CNL-17-100

Clinch River Nuclear Site
NRC Docket No. 52-047

Subject: Response to Request for Additional Information Number 5, Questions 02.05.01-03 and 02.05.01-05, Regarding Basis Geologic and Seismic Information in Support of Early Site Permit Application for Clinch River Nuclear Site

Enclosure 1
Response to NRC RAI Number 5, Question 02.05.01-03

Figure 2.5.1-83 (Sheet 1 of 2) Interpreted Seismic Reflection Profile from Tennessee Highway 95

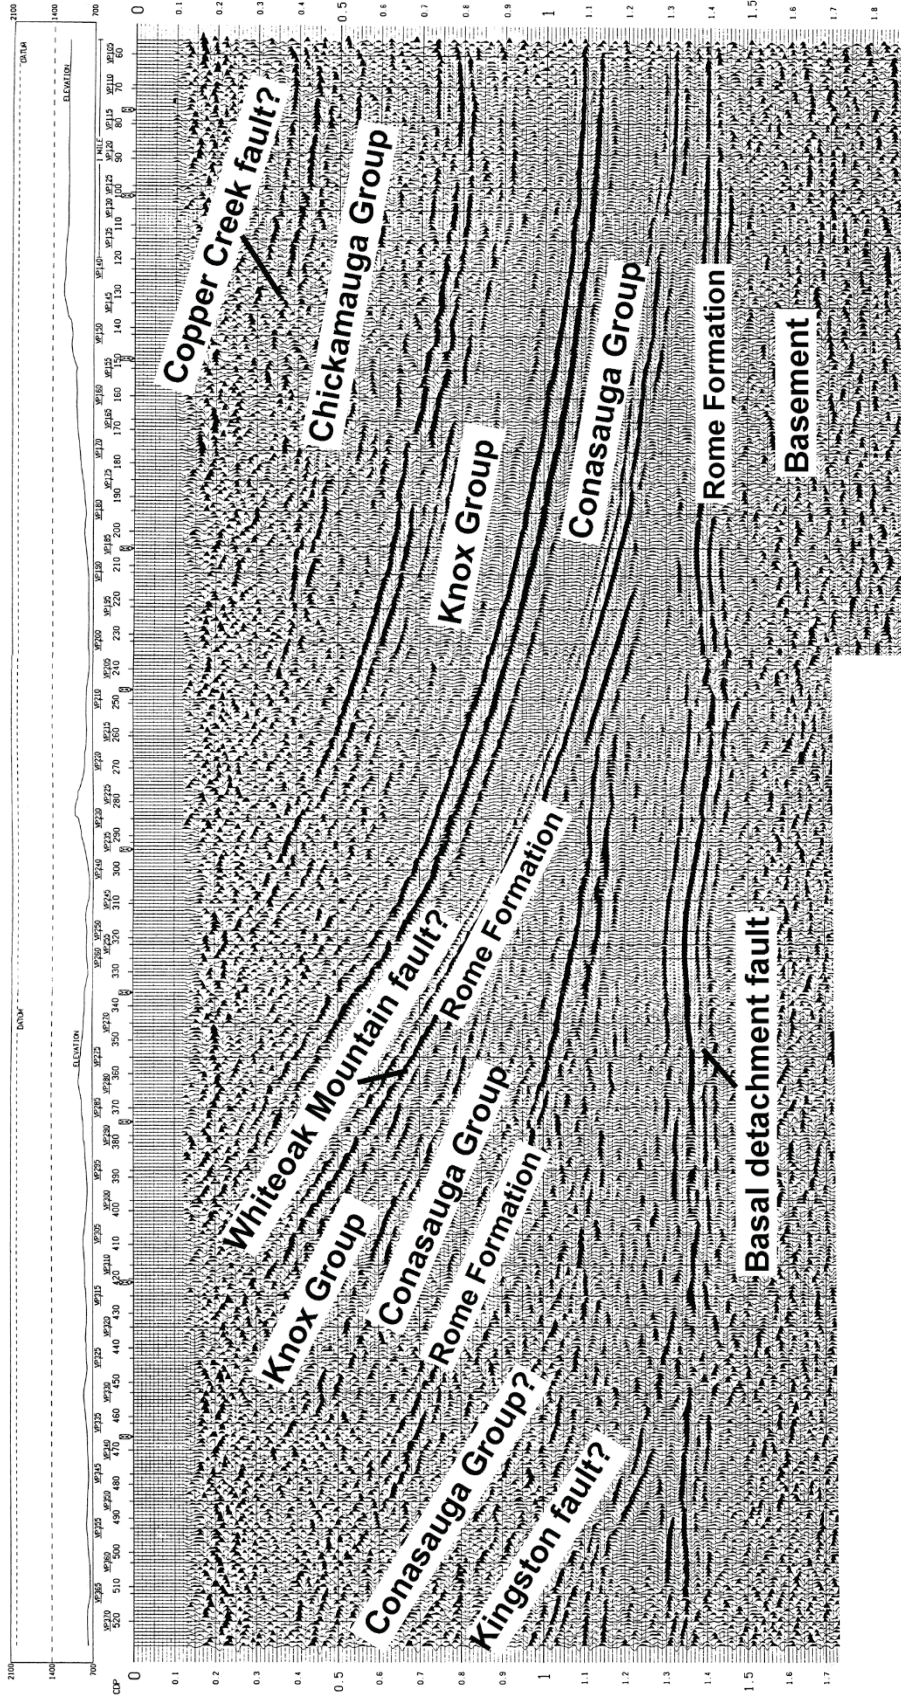
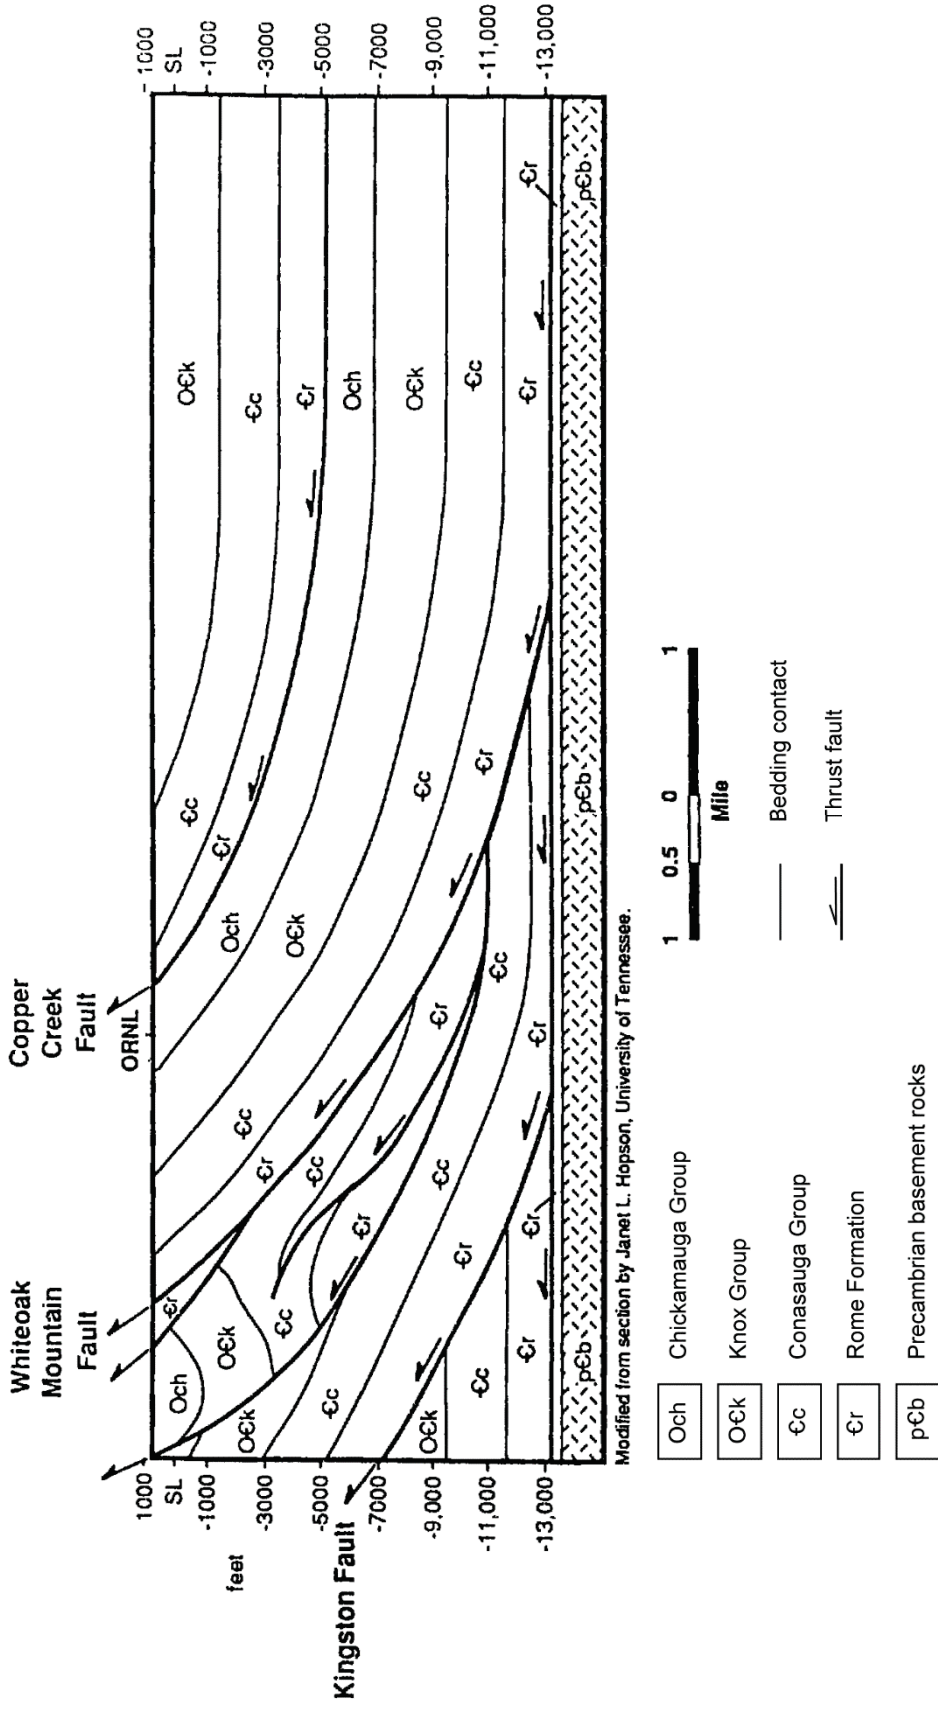
Thrust faults in foreland fold-thrust belts worldwide have been successfully imaged using seismic reflection geophysical techniques (e.g., References 1 through 5). Therefore, this technique was applied to identify possible similar subsurface structures at the CRN Site. The two seismic reflection surveys conducted at the CRN Site do not appear to image foreland fold-thrust belt faults, including previously mapped faults near the site (Whiteoak Mountain, Chestnut Ridge, and Copper Creek faults). The reasons that these faults were not imaged is not a function of the inability of seismic reflection to image foreland fold-thrust belt faults, but the location of the survey lines relative to the faults. For instance, the trace of the Whiteoak Mountain fault is approximately 10,000 ft northwest of the northwestern extent of both seismic reflection survey lines. Projection of this fault into the subsurface indicates it likely occurs at elevations of -7,000 ft with respect to mean sea level (MSL) to -8,000 ft MSL at the CRN Site, which is well below the depth imaged in seismic reflection profiles SRL-1 and SRL-2. The mapped trace of the Copper Creek fault crosses seismic reflection survey line SRL-1 at its southeastern end, which occurs where loss of data redundancy (fold) precludes reliable imaging or interpretation (Reference 6). The Chestnut Ridge fault of Lemiszki (Reference 7) is a relatively small-displacement thrust fault interpreted to juxtapose Chepultepec Dolomite against the Kingsport Formation (also dolomite) below the CRN Site (see cross section in SSAR Figure 2.5.1-64). The Chestnut Ridge fault trace occurs approximately 1,000 to 1,400 ft

northwest of seismic reflection profiles SRL-2 and SRL-1, respectively. Based on the cross section of Lemiszki (Reference 7; see SSAR Figure 2.5.1-64), the Chestnut Ridge fault should occur beneath the CRN Site at approximately 2,500 ft depth. The estimated depth imaged by the seismic reflection profiles SRL-1 and SRL-2 is approximately 3,500 ft, based on two-way travel times and inferred seismic velocities (Reference 6). Therefore, the fault could be imaged in the seismic reflection profiles, but there is no apparent offset of reflectors. Potential explanations for the lack of conspicuous offset in the seismic reflection data include: 1) there is not enough acoustic contrast between the two similar units to produce a strong seismic reflection, or 2) there is little stratigraphic offset.

Seismic reflection has been a reliable geophysical method for successfully imaging stratigraphy and faults in foreland fold-thrust belts, including the southern Appalachian Valley and Ridge (e.g., References 2.5.1-102 and 2.5.1-316). Hatcher et al. (Reference 2.5.1-102) present numerous balanced geologic cross sections throughout the eastern Tennessee Valley and Ridge Province that rely heavily on seismic reflection data, demonstrating the applicability of this method to delineate the subsurface structural geology in a foreland fold-thrust system. Additionally, Hatcher et al. (Reference 2.5.1-9) present a line drawing of their interpretation of a seismic reflection profile that was acquired along Tennessee Highway 95, approximately 2 mi. northeast of the CRN Site (Figure 2.5.1-83). Hatcher et al. (Reference 2.5.1-9) interpret the Whiteoak Mountain and Copper Creek faults on this profile, based on the mapped locations of the faults relative to the seismic reflection survey line and, for the Whiteoak Mountain fault, strong reflectors in the hanging wall that truncate reflectors in the interpreted footwall (Figure 2.5.1-83). Similar truncations are not visible along the Copper Creek fault in this seismic reflection profile, which is interpreted by Hatcher et al. (Reference 2.5.1-9) to represent parallel bedding above and below the fault (Figure 2.5.1-83, Sheet 2 of 2).

New SSAR Figure 2.5.1-83 is being added to SSAR Subsection 2.5.1:

Figure 2.5.1-84 Seismic Reflection Profile from Biscayne Bay, Florida, Showing Large Scale Sag Features Attributed to Hypogene Dissolution

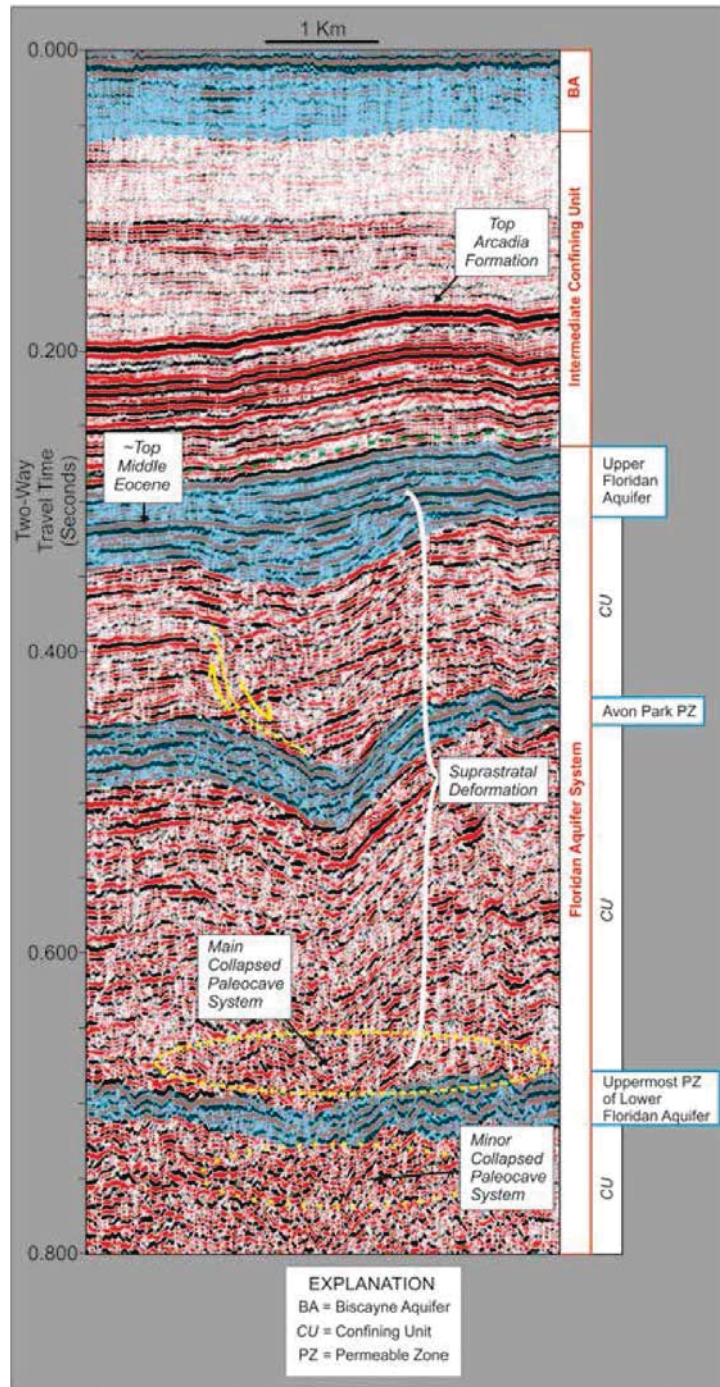
The seismic reflection data at the CRN Site was primarily collected to evaluate the bedrock structure and potential thrust faults in foreland fold-thrust belt as discussed above. The inherent uncertainty in seismic reflection data limits its capability to address the presence of karst. However, seismic reflection has been used to successfully evaluate karst at other sites. Discussions of hypogene dissolution examples in Biscayne Bay, Florida (References 8 through 10), and in the Shenandoah Valley, Virginia (Reference 11) are illustrated with figures from these references (see SSAR Figures 2.5.1-84 and 2.5.1-85). Geophysical studies in Biscayne Bay, Florida, demonstrate the applicability of seismic reflection to identify karst dissolution features. However, the karst features identified in Biscayne Bay are much larger than voids expected at the CRN Site.

The mixing of fresh water and salt water in coastal settings can also result in hypogene dissolution. Cunningham and Walker (Reference 2.5.1-41) and Cunningham et al. (Reference 2.5.1-318) describe multistoried vertical sag features evident in high resolution seismic reflection profiles from Biscayne Bay, Florida (Figure 2.5.1-84). They interpreted these stacked sag features, which range in diameter from 170 m (560 ft) to 3.2 km (10,500 ft), as evidence for coalesced, collapsed paleocave systems. Cunningham and Walker (Reference 2.5.1-41) proposed two hypogene mechanisms to explain these broad structural sags. They postulate upward flow driven by Kohout convection with dissolution by mixed fresh and saline groundwaters (Figure 2.5.1-85) and/or upward ascension of hydrogen-sulfide-charged groundwater derived from dissolution and reduction of calcium sulfates in deeper strata. Additionally, the faults associated with these collapse features may serve as pathways for upward ground water flow. This setting is highly susceptible to both epigenic and hypogenic karst processes due to the high porosity and permeability of Florida limestones and the frequent mixing of salt water and fresh water in groundwaters near the coast (Reference 2.5.1-295).

New Figure 2.5.1-84 is being added to SSAR Subsection 2.5.1:

Figure 2.5.1-29. (Sheet 1 of 2) Site Location Geologic Map Showing Borings

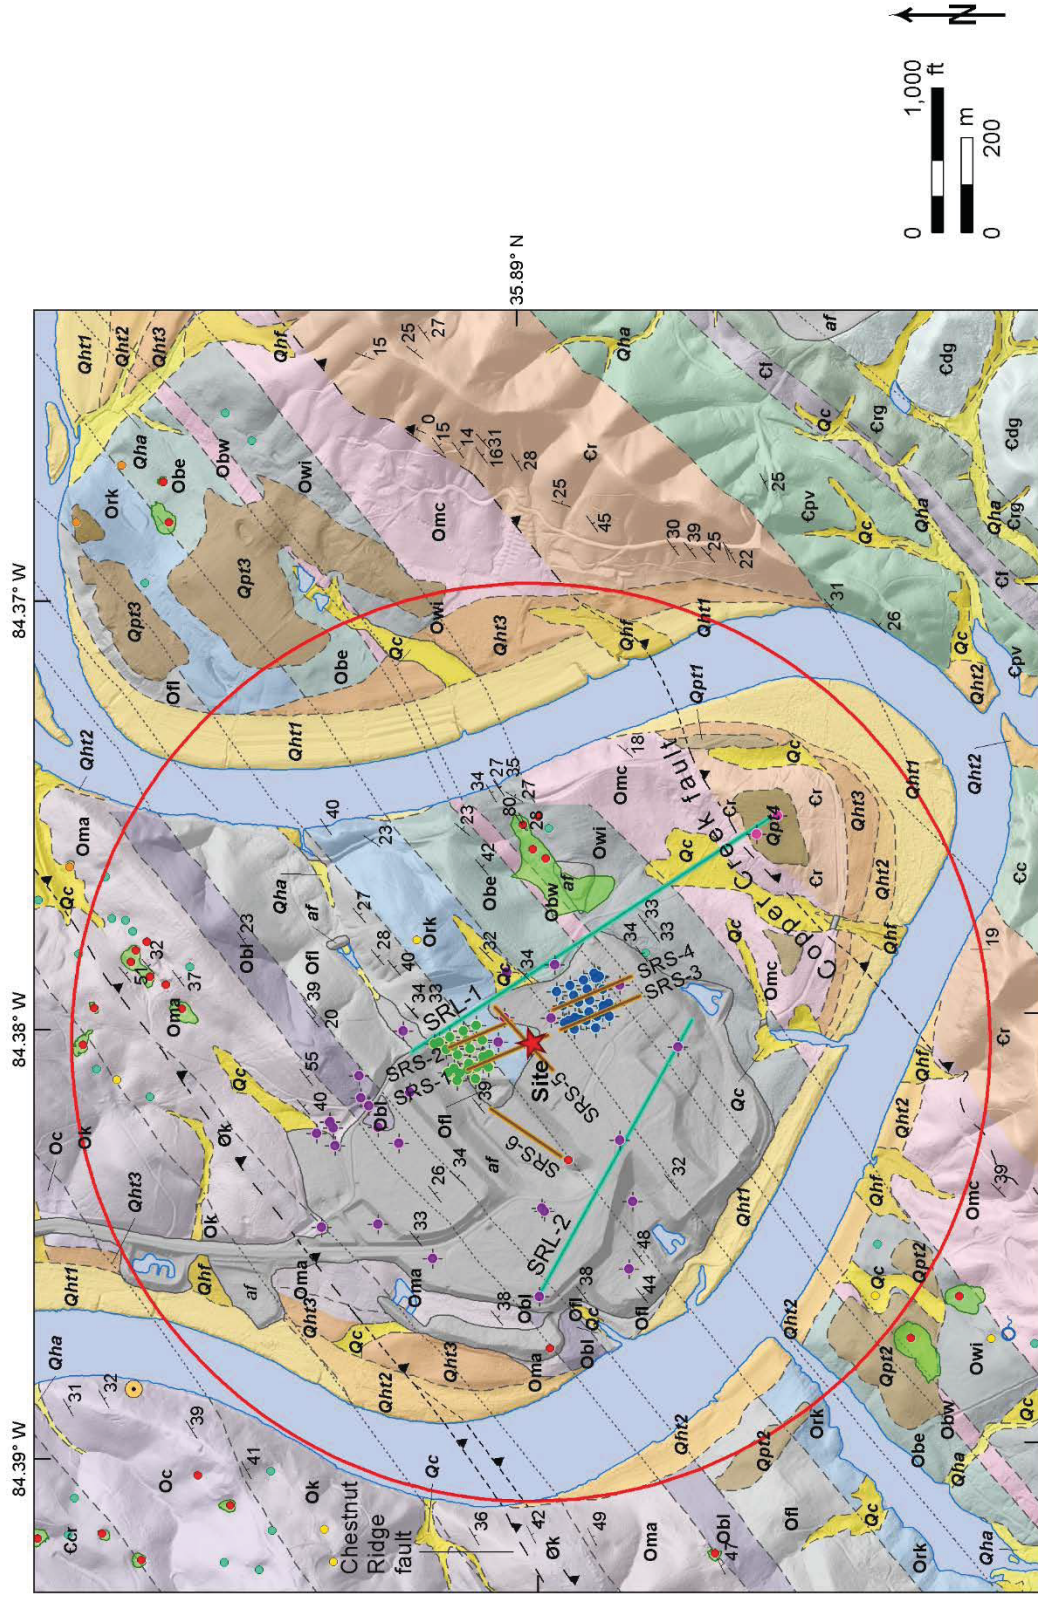
- a. The primary objective of the seismic refraction surveys was to map the depth to bedrock at the Clinch River Nuclear (CRN) Site, although these data were also reviewed to potentially identify subsurface karst features. As discussed in SSAR Subsection 2.5.1.2.5.1.2, the seismic refraction data are not effective in terms of assessing the presence or absence of karst features, primarily because the lines were collected in areas that had been graded during Clinch River Breeder Reactor Project (CRBRP) activities in the 1970s and 1980s. In some places, significant thicknesses of bedrock had been removed and a thin layer of fill emplaced over the graded bedrock surface. In other places, thick fill had been emplaced to backfill the 1983 excavation or to fill small valleys. The seismic refraction profiles primarily show the extent of fill and depth to bedrock.*

Six seismic refraction lines were acquired at the CRN Site (Figure 2.5.1-29). The data are presented as seismic tomography models (Figure 2.5.1-86). Such models can be used to resolve complex velocity structure that cannot be imaged using layer-based modelling techniques (Reference 2.5.1-214). The primary objective of the seismic refraction surveys was to map the depth to bedrock in graded and filled areas within the central portion of the site. The data were also reviewed to identify anomalies that might indicate the presence of geologic structures such as blind faults or large karst dissolution features beneath the fill. The resolution of these data is not sufficient to identify small-scale features (less than 10 ft). The results of this review are presented in Subsection 2.5.1.2.5.1.2.

Existing SSAR Figure 2.5.1-29 is being replaced with the following:
